# HDC ADMINISTRATIVE APPROVALS

June 04, 2025

# 1. 95 Daniel Street

# 95 DANIEL STREET

REAR PERSPECTIVE

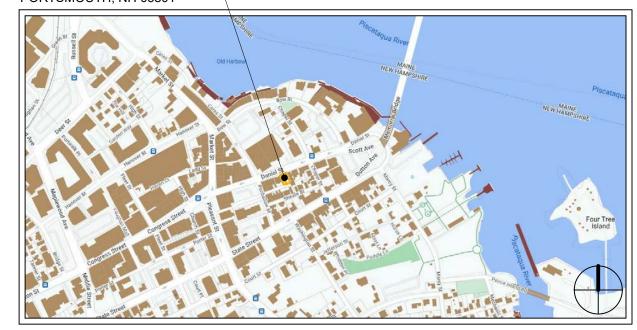
- REMOVAL OF PREVIOUSLY APPROVED WINDOWS ON WEST ELEVATION CONTINUATION OF BRICK SHELF AROUND PERIMETER OF FOUNDATION WALL ADDITION OF GATES ON EITHER SIDE OF BUILDING TO CONCEAL ALLEY WAYS
- ADDITION OF GRANITE STEPS AT BOTH FRONT AND REAR ENTRY
- REMOVAL AND RELOCATION OF EXHAUST VENTS
- ADDITION OF PILASTERS WITH SCROLL DETAILS ON REAR ELEVATION TO MATCH EXISTING
- RELOCATION OF CONDENSER WITH SCREENING

PROPOSED SOUTH ELEVATION

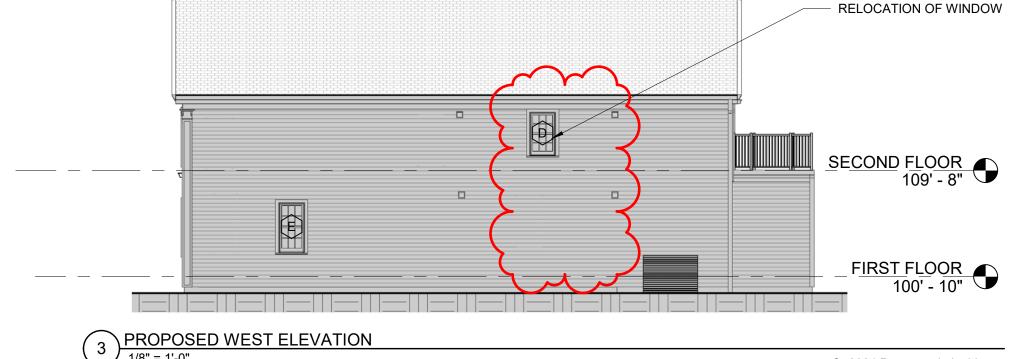
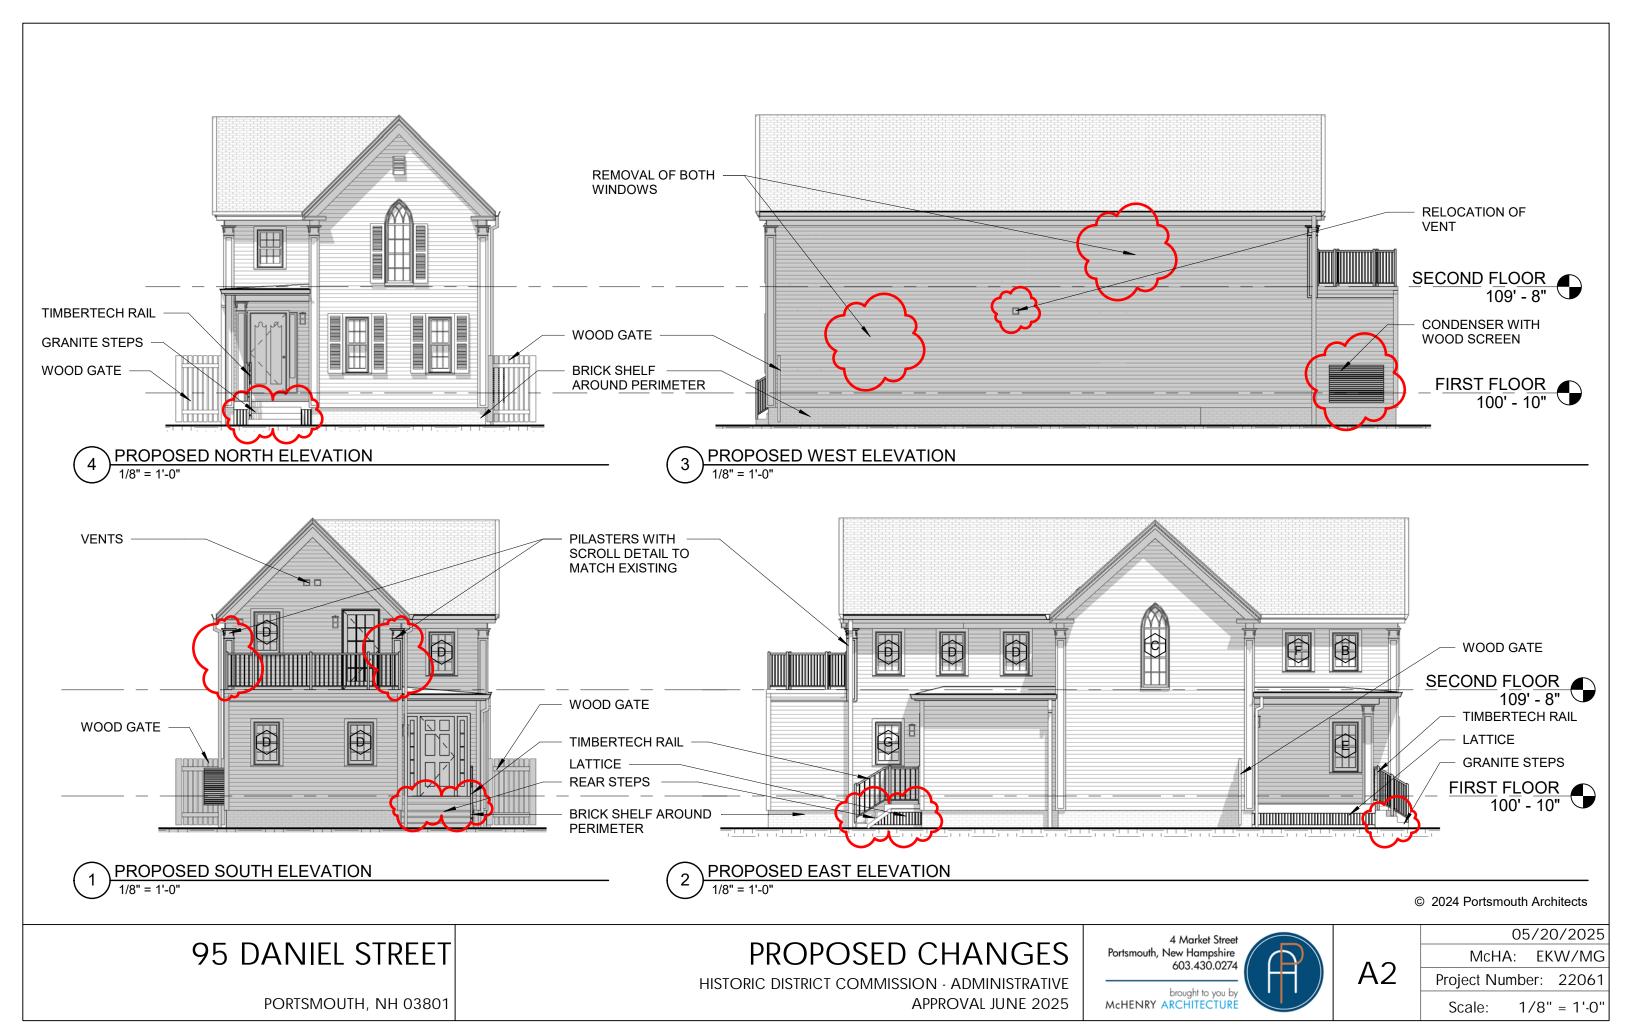
- 1-STORY ADDITION ON REAR OF BUILDING TO PROVIDE ENTRY/MUDROOM SPACE.
- REMOVAL OF EXISITNG REAR ENTRY DOOR AND ADJACENT "D" WINDOW.

- REMOVAL OF PREVIOUSLY APPROVED DOOR ON EAST **ELEVATION**
- RELOCATION OF "E" WINDOW ON WEST ELEVATION.
- RELOCATION OF LOUVERS FOR VENTILATION.
- ADDITION OF COPPER GUTTERS AND DOWNSPOUTS

INSTALLED VIEW FROM PICKERING STREET

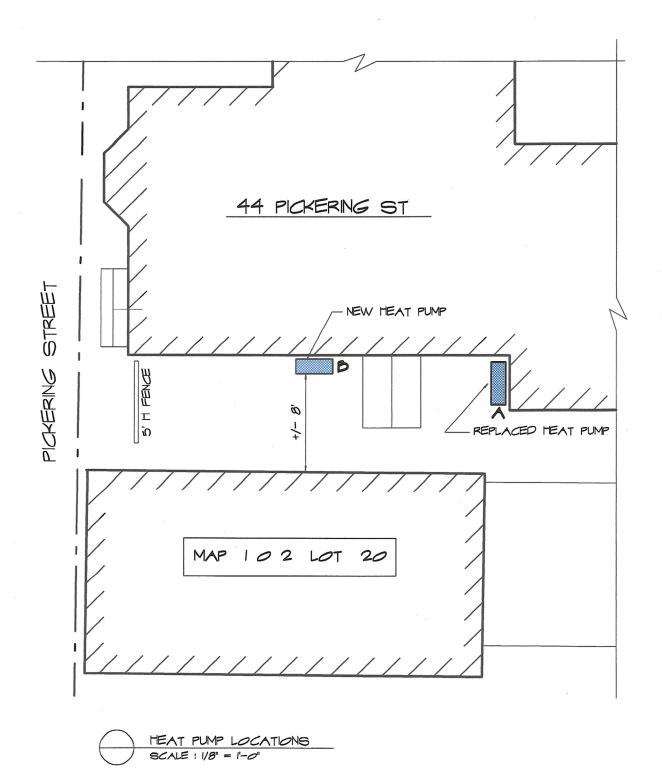
Every attempt was made to keep the equipment hidden from view as much as possible and limit visible exposure from street views. We placed the 2nd condenser in close proximity to the original condenser location and behind a fence intended to help obstruct the view. One exterior line was required on the exterior of the building to avoid an interior staircase, but it was painted to match the siding and limit visible impact.

As approved

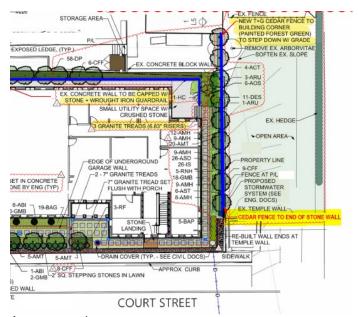
7. East façade: Granite base lowered to align with lowered grade (granite exposure unchanged). Omit wood fence along east property line.
